Technical Bulletin 201 12.2019

Contents

Circuit Diagram

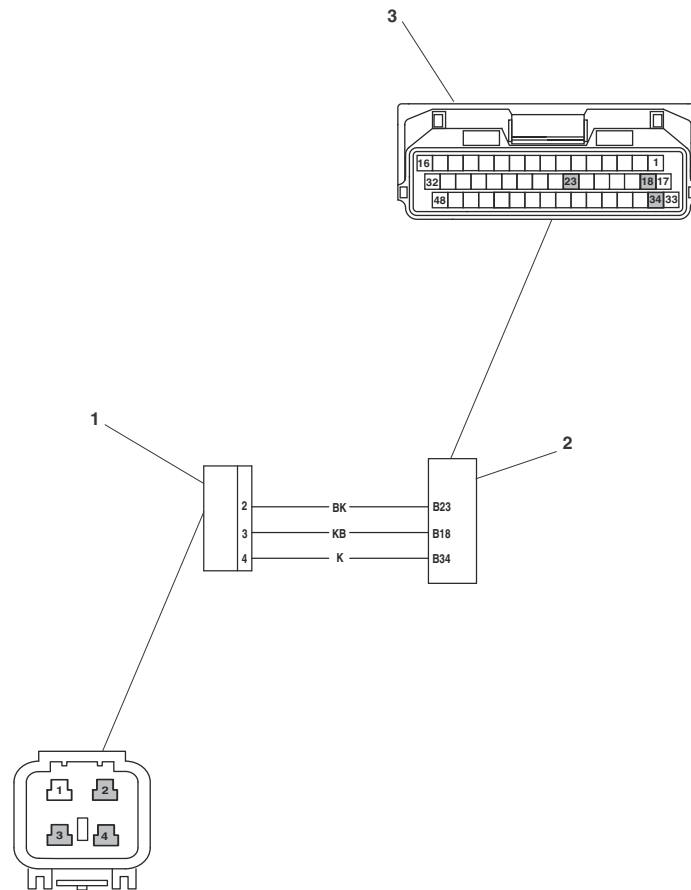
Gear Position Sensor Pinpoint Test - Street Twin from VIN 914793, Street Scrambler from VIN 914448, Speed Twin, Thruxton TFC

Test	Result	Action
1 Reset the neutral position adaption (see Neutral Position Adaption), clear fault code and run engine.	Fault cleared	Action complete - quit test
	Fault still present	Proceed to test 2
2 Check cable and terminal integrity: - Engine ECM pin B18 - Engine ECM pin B23 - Engine ECM pin B34	OK	Disconnect sensor and proceed to test 3
	Faulty	Rectify fault, proceed to test 6
3 Check cable for short circuit: - Engine ECM pin B23 to ground - Engine ECM pin B34 to ground	OK	Proceed to test 4
	Short circuit	Locate and rectify wiring fault, proceed to test 6
4 Check cable continuity: - Engine ECM pin B23 to sensor pin 2 - Engine ECM pin B18 to sensor pin 3 - Engine ECM pin B34 to sensor pin 4	OK	Proceed to test 5
	Open circuit	Locate and rectify wiring fault, proceed to test 6
5 Check cable for short circuit: - Engine ECM pin B23 to ECM pin B34 - Engine ECM pin B23 to ECM pin B18	OK	Renew gear position sensor and contact pin and proceed to test 6

Circuit Diagram

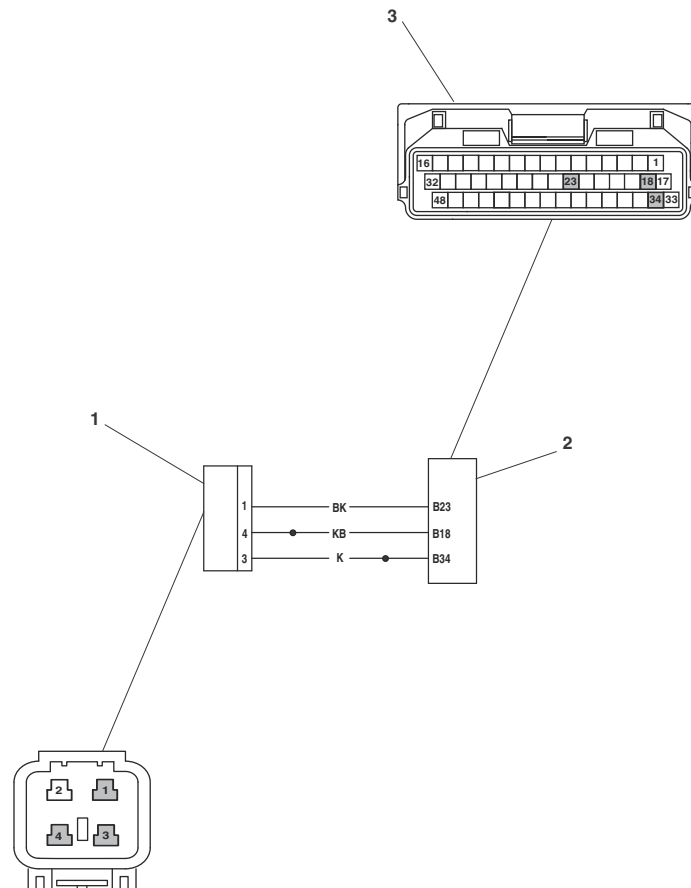
Gear Position Sensor Pinpoint Test - Scrambler 1200 XC and Scrambler 1200 XE

Test	Result	Action
1 Reset the neutral position adaption (see Neutral Position Adaption), clear fault code and run engine.	Fault cleared	Action complete - quit test
	Fault still present	Proceed to test 2
2 Check cable and terminal integrity: - Engine ECM pin B23 - Sensor pins 1, 3, 4	OK	Disconnect sensor and proceed to test 3
	Faulty	Rectify fault, proceed to test 6
3 Check cable for short circuit: - Engine ECM pin B23 to ground - Engine ECM pin B34 to ground	OK	Proceed to test 4
	Short circuit	Locate and rectify wiring fault, proceed to test 6
4 Check cable continuity: - Engine ECM pin B23 to sensor pin 1 - Engine ECM pin B18 to sensor pin 4 - Engine ECM pin B34 to sensor pin 3	OK	Proceed to test 5
	Open circuit	Locate and rectify wiring fault, proceed to test 6
5 Check cable for short circuit: - Engine ECM pin B23 to ECM pin B34	OK	Renew gear position sensor and contact pin and proceed to test 6

Circuit Diagram

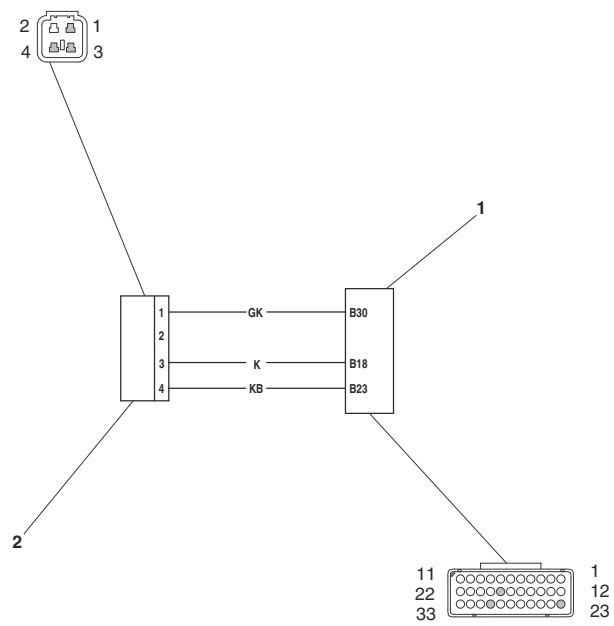
Gear Position Sensor Pinpoint Test - Street Triple RS and Street Triple S 660 cc

Test	Result	Action	
1	Reset the neutral position adaption (see Neutral Position Adaption), clear fault code and run engine.	Fault cleared	Action complete - quit test
		Fault still present	Proceed to test 2
2	Check cable and terminal integrity: - Engine ECM pin B30	OK	Disconnect sensor and proceed to test 3
		Faulty	Rectify fault, proceed to test 6
3	Check cable for short circuit: - Engine ECM pin B18 to ground - Engine ECM pin B30 to ground	OK	Proceed to test 4
		Short circuit	Locate and rectify wiring fault, proceed to test 6
4	Check cable continuity: - Engine ECM pin B18 to sensor pin 3 - Engine ECM pin B23 to sensor pin 4 - Engine ECM pin B30 to sensor pin 1	OK	Proceed to test 5
		Open circuit	Locate and rectify wiring fault, proceed to test 6
5	Check cable for short circuit: - Engine ECM pin B30 to Engine ECM pin B18 - Engine ECM pin B30 to Engine ECM pin B23 - Engine ECM pin B30 to Engine ECM pin A08 - Engine ECM pin B30 to Engine ECM pin A21	OK	Renew gear position sensor and contact pin and proceed to test 6

Circuit Diagram

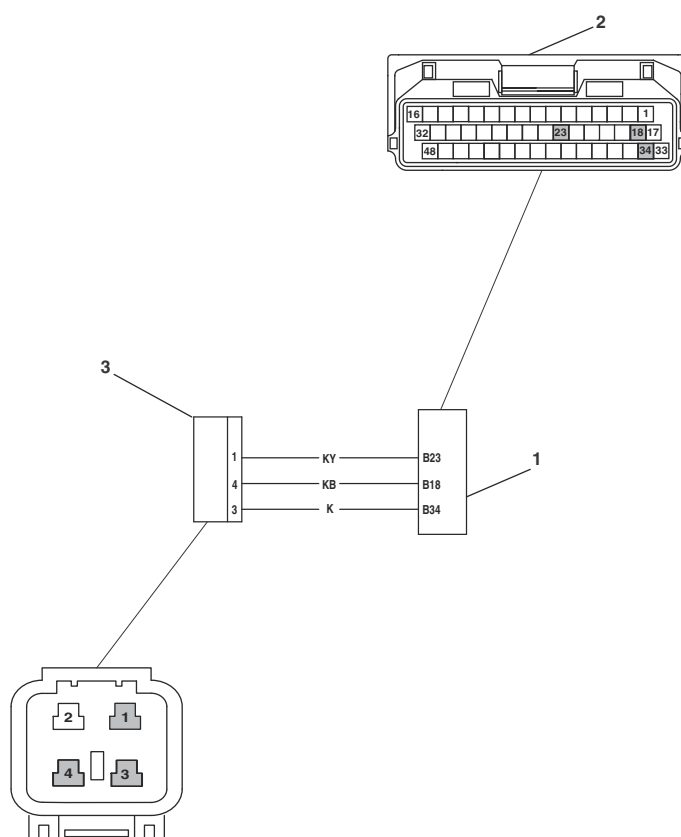
Gear Position Sensor Pinpoint Test - Daytona Moto2™ 765

Test	Result	Action
1 Reset the neutral position adaption (see Neutral Position Adaption), clear fault code and run engine.	Fault cleared	Action complete - quit test
	Fault still present	Proceed to test 2
2 Check cable and terminal integrity: - ECM pin B23 Gear position sensor pin 1 Gear position sensor pin 3 Gear position sensor pin 4	OK	Disconnect sensor and proceed to test 3
	Faulty	Rectify fault, proceed to test 6
3 Check cable for short circuit: - ECM pin B23 to ground - ECM pin B34 to ground	OK	Proceed to test 4
	Short circuit	Locate and rectify wiring fault, proceed to test 6
4 Check cable continuity: - ECM pin B23 to sensor pin 1 - ECM pin B34 to sensor pin 3 - ECM pin B18 to sensor pin 4	OK	Proceed to test 5
	Open circuit	Locate and rectify wiring fault, proceed to test 6
5 Check cable for short circuit: - ECM pin B23 to ECM pin B44	OK	Renew gear position sensor and contact pin and proceed to test 6

Frame and Bodywork

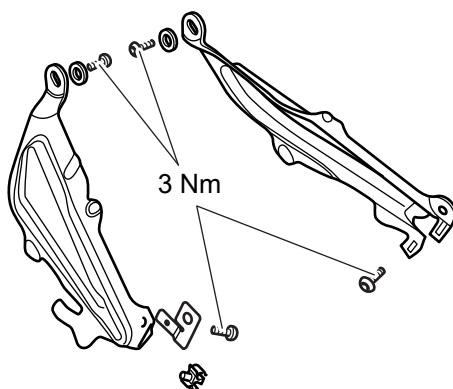
The torque figure has changed. If loosened or removed for any reason the fixing(s) must be torqued as required.

Application	Torque (Nm)	Notes
Side infill panels	3 Nm

Frame and Bodywork

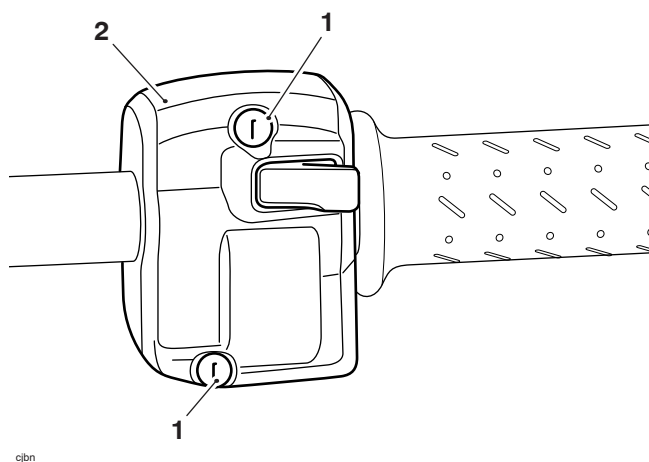
The torque figure has changed. If loosened or removed for any reason the fixing(s) must be torqued as required.

Application	Torque (Nm)	Notes
Left hand switch housing	2 Nm

Motorcycles with a Single Dot Alignment Mark

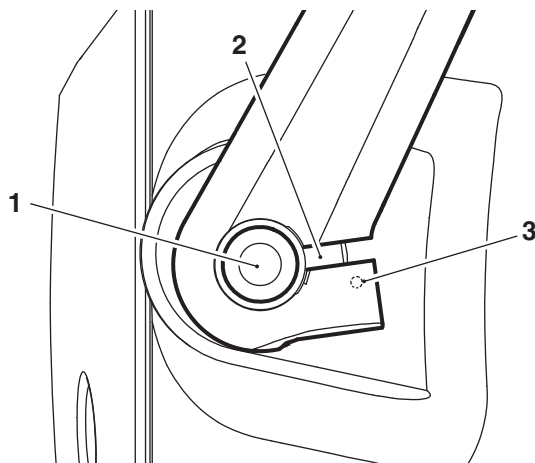
A new clutch cable was introduced to the above models from VIN 693388 and is retrofittable. Triumph parts department no longer support the original clutch cable. The difference between the original and new condition clutch cable is that the inner cable's free length at the clutch actuation lever is 18 mm longer than the original. The additional length is to allow the repositioning of the clutch actuation lever.

1. Rotate the clutch shaft clockwise until the shaft makes contact with the clutch pressure plate bearing.
2. Align the split in the clutch actuation lever to the single dot alignment mark on the clutch cover.
3. While holding the clutch shaft in position, rotate the actuation lever two splines anticlockwise then fit the arm to the shaft.

Motorcycles with Single Dot and Double Dot Alignment Marks

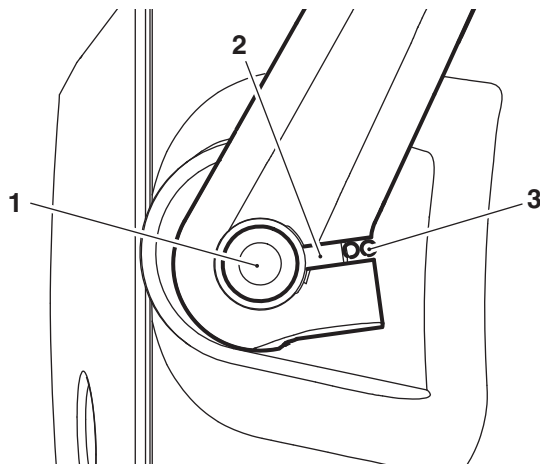
1. Rotate the clutch shaft clockwise until the shaft makes contact with the clutch pressure plate bearing.
2. Align the split in the clutch actuation lever to the double dot alignment mark on the clutch cover then fit the arm to the shaft.

Description: Camshaft Frame Installation

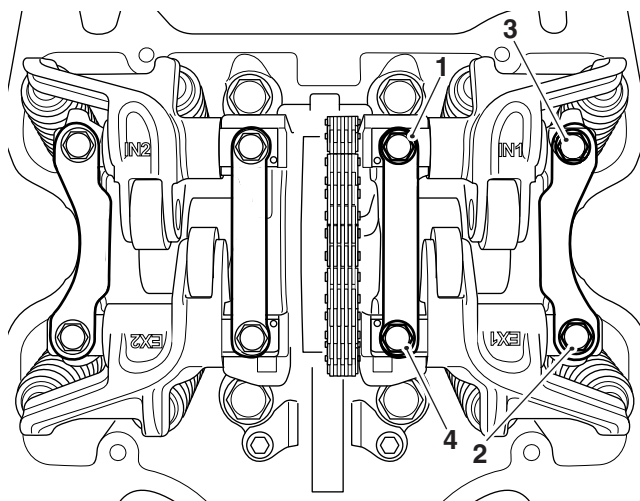
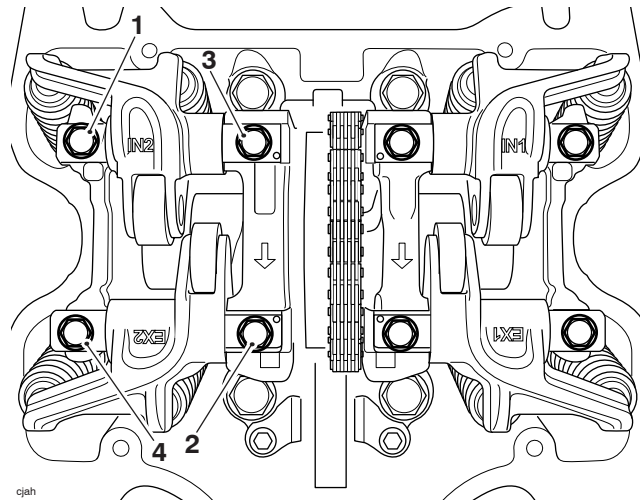
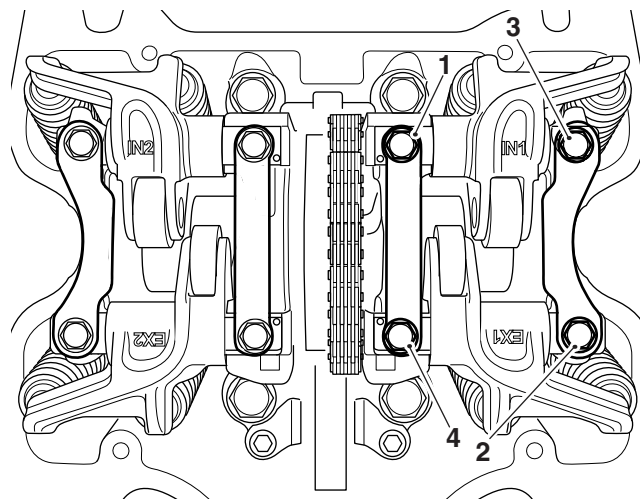
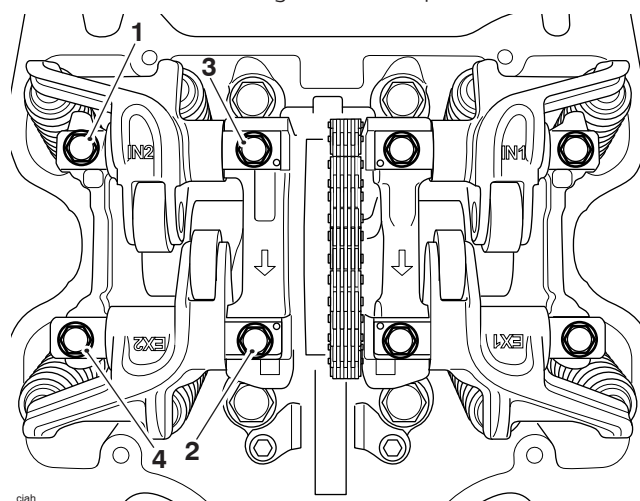
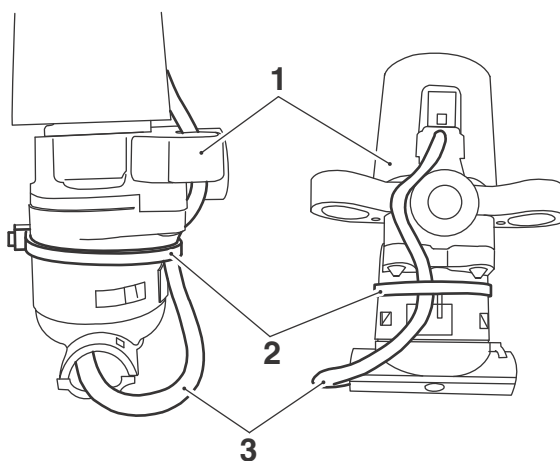
New camshaft frame bolts have been introduced to the above models from Engine Number 944903 (all markets except Brazil) and from Engine Number 960154 (Brazil only) and these have a new torque tightening value of 12 Nm.

Models prior to these engine numbers will remain at 10 Nm.

1. In the sequence shown below,
 - Tighten cylinder one camshaft frame fixings, until the camshaft frames are in full contact with the cylinder head. Tighten the fixings in the sequence shown below to 5 Nm.

- Tighten cylinder two camshaft frame fixings, until the camshaft frames are in full contact with the cylinder head. Tighten the fixings in the sequence shown below to 5 Nm.

- Tighten cylinder one camshaft frame fixings in the sequence shown below to 12 Nm.

- Tighten cylinder two camshaft frame fixings in the sequence shown below to 12 Nm.
